**BEFORE THE HEARINGS PANEL
FOR THE QUEENSTOWN LAKES PROPOSED DISTRICT PLAN**

IN THE MATTER of Stage 3b of the
Proposed District Plan

**REBUTTAL EVIDENCE OF BRIDGET MARY GILBERT
ON BEHALF OF QUEENSTOWN LAKES DISTRICT COUNCIL**

**LANDSCAPE ARCHITECTURE
RURAL VISITOR ZONE AND SETTLEMENT ZONE – REZONINGS**

Figure 1: Wye Creek RVZ (Source: C Vivian evidence)

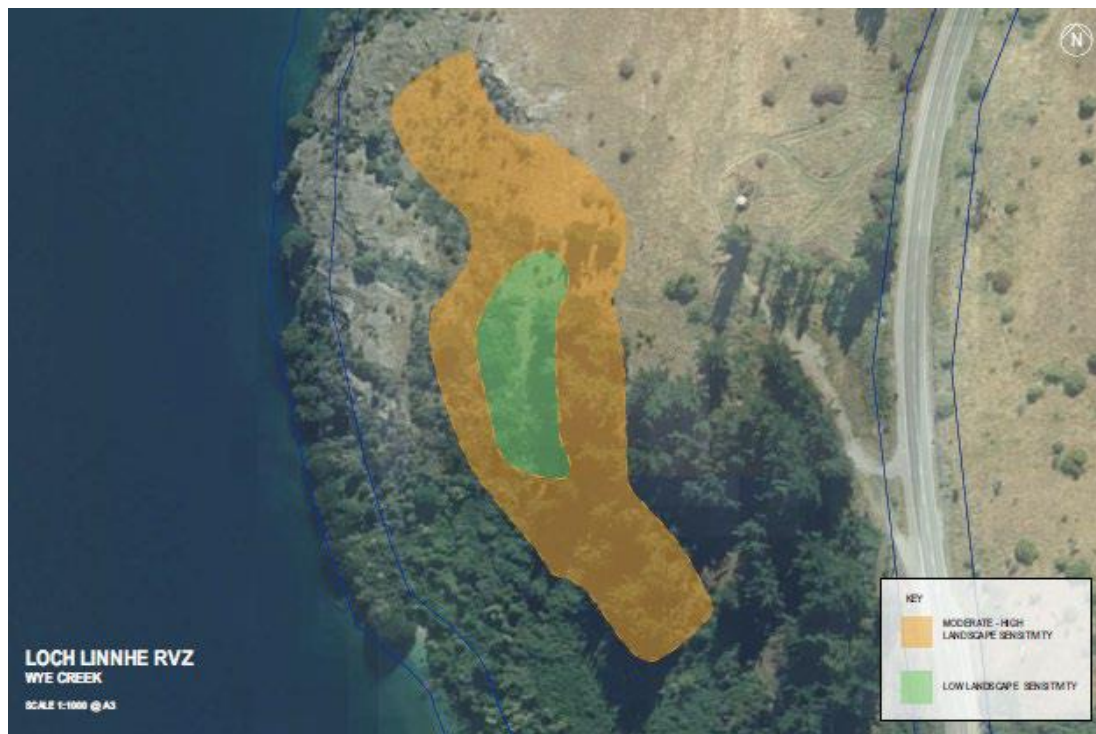
3.3 I disagree with Mr Espie that the proposed (tailored) Rural Visitor Zone sought for the Wye Creek site is appropriate from a landscape perspective.

3.4 My disagreement is based on the following factors:

- (a) The absence of detailed contour information and a thorough landscape analysis, supporting:
 - (i) the extent of RVZ sought in this location; and
 - (ii) the breakdown of the landscape sensitivity ratings across the area identified in Mr Vivian's recommended provisions.

- (b) A potential underestimation of the scale of adverse visual effects in relation to views from Lake Wakatipu, which is an Outstanding Natural Landscape (**ONL**). In this regard, I note that a marina is envisaged at Homestead Bay (suggesting the potential boating activity throughout the southern arm of the lake is likely to increase), and the exotic vegetation throughout the Wye Creek RVZ could be removed as of right.

- (c) A potential underestimation of the scale of adverse landscape effects, particularly in light of the potential visibility of RVZ development at Wye Creek in views from Lake Wakatipu. I do, however, acknowledge that care has been taken to manage adverse visual effects in relation to views from SH6.

- (d) In my opinion, successfully integrated development throughout the southern arm of the lake is typically: located in natural localised landform hollows and/or well integrated by plantings; and comprises a sympathetic building design. The proposed Wye Creek RVZ provisions as currently proposed would not give certainty of such an outcome.

- 3.5** Put simply, I consider that there is inadequate ‘base’ information (particularly in relation to the topographical patterning of the land), and subsequent landscape and visual effects analysis to support the Wye Creek RVZ.

- 3.6** I remain of the view that a thorough landscape assessment is required that can give confidence that the character of landscape change associated with a Wye Creek RVZ will satisfy the fundamental landscape policy requirements in ONLs, that development: protects landscape values; and, is reasonably difficult to see.

- 3.7** Based on my site visit, I consider that the landscape sensitivity of this location points to appropriate RVZ development at Wye Creek including a well-crafted structure plan approach that responds to the landscape opportunities and constraints identified in my evidence in chief, with a minimum restricted discretionary activity status for buildings applying. I note in this regard it would appear that Mr Espie has misinterpreted my recommendations as an ‘either or’ scenario.⁶
